Austin Transportation Department

RE: I-35 Capital Express North Project Comments for Public Hearing

Bicycle and Pedestrian Crossings

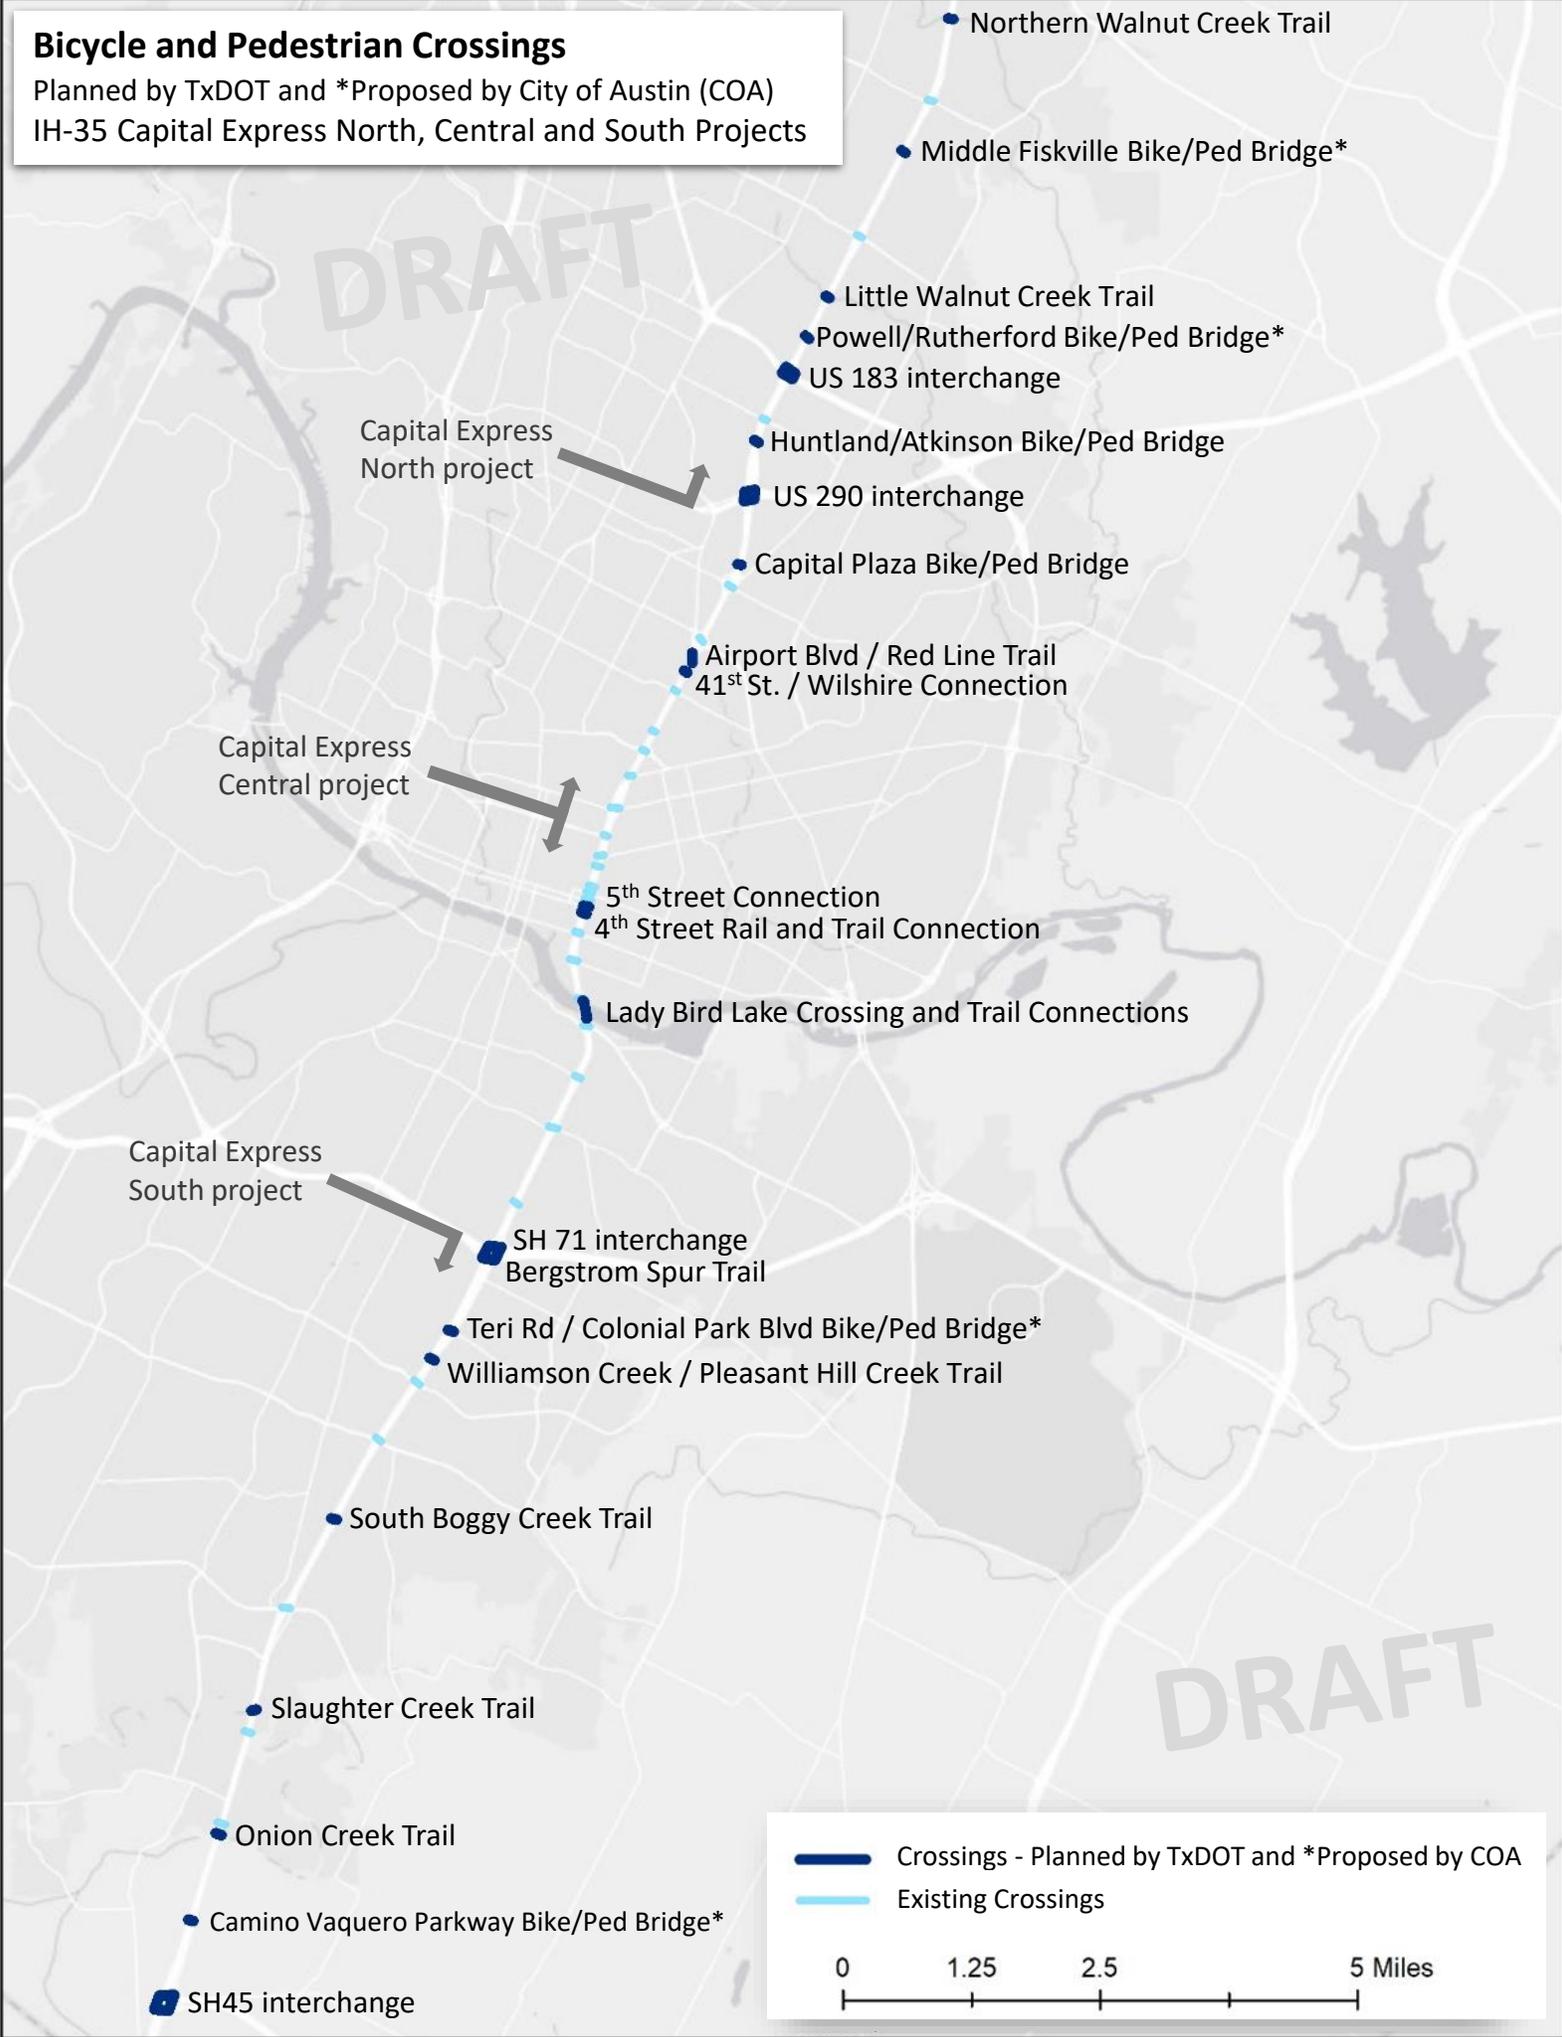
Multimodal Crossings: Plans for the north segment currently propose few new east-west crossings. The City has transmitted requests to TxDOT for additional pedestrian and bicycle crossings in letters dated January 4, and January 19, 2021. Many crossings are included in the master plans

for Urban Trails and Parks which the Austin City Council adopted in 2014 and 2019, particularly north of U.S. 290. These crossings would relieve connectivity gaps, reduce mobility barriers for lower income populations, and mitigate hot spots for pedestrian-involved crashes. The City requests continued coordination with TxDOT to ensure the design of the Capital Express North project does not preclude or complicate these proposed future crossings that may be developed subsequent to completion of the I-35 North project. A map of these proposed crossings of the Capital Express North project is attached. The Austin Transportation Department is interested in partnering with TxDOT to bring these proposed crossings to a future fruition.
